NUREG-1874

Recommended Screening Limits for Pressurized Thermal Shock (PTS)

Manuscript Completed: March 2007
Date Published: March 2010

Figure 2.1. Data on which the RT_{NDT} epistemic uncertainty correction is based

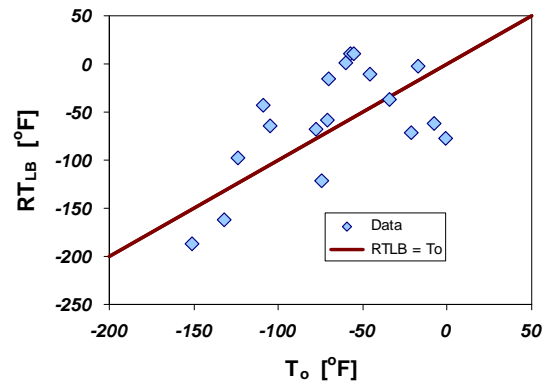
From the descriptions of the parameters RT_{LB} (lower bound reference temperature) and T_o (fracture toughness reference temperature) provided in the documentation, it seems that these two parameters should have a more systematic relationship and, in particular, that RT_{LB} should always be greater than or equal to T_o . Nevertheless, Figure 2.1, which displays the data on which the RT_{NDT} epistemic uncertainty correction is based, shows that RT_{LB} can be considerably less than T_o . Is there a problem with our understanding of how RT_{LB} and T_o relate to one another, or is there some inconsistency in the data shown in Figure 2.1?

The review correctly identifies that the data in Figure 2.1 for which RT_{LB} falls below T_o are erroneous. The change specification for the Fracture Analysis of Vessels—Oak Ridge (FAVOR) Code detailed in Appendix A provides a detailed explanation of the origins of these erroneous data and develops a revised epistemic uncertainty correction for RT_{NDT} that does not rely on these data.

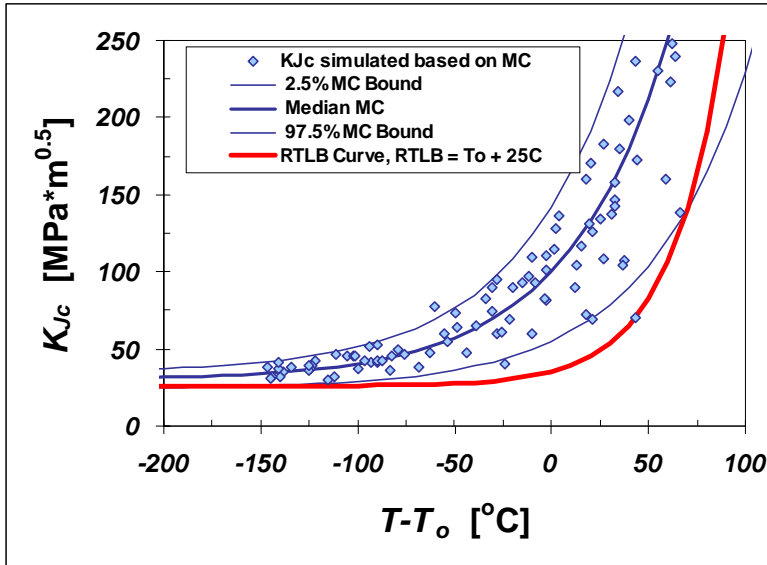
Question 2: When the RT_{LB} data in Table 4.2 are plotted versus T_o (using the corrected value of T_o identified in Question 1), the plot shown below results. (Note that three T_o values have been added to the original table for materials 16–18; these values are backed in blue.) Is there a reason why 7 of the data points have RT_{LB} values that are lower than T_o (these data are indicated in red print in Table 4.2 above), while 11 of the values have RT_{LB} values higher than T_o ?

- RT_{LB} should exceed T_o .
- For well-populated data sets where K_{Ic} or K_{Jc} values are measured in transition, RT_{LB} will be estimated to exceed T_o .
- The average amount by which RT_{LB} exceeds T_o for the 11 data sets shown in black type in Table 4.2 is in good agreement with our simulation based on the Master Curve.

- RT_{LB} will fall below T_o if the only K_{Ic} data available for analysis lie on or near the lower shelf.

Action: Modify the data basis for the $\Delta RT_{EPISTEMIC}$ distribution used by FAVOR. The data used to establish the $\Delta RT_{EPISTEMIC}$ distribution should include **only** those data sets from Table 4.2 (see pages 4 and 5 of this memorandum) for which $RT_{LB} > T_o$. Also, include the three new T_o values given for materials 16, 17, and 18 in the FAVOR Theory manual. The analysis methodology used to establish the $\Delta RT_{EPISTEMIC}$ distribution from these data should be the same as that used currently.
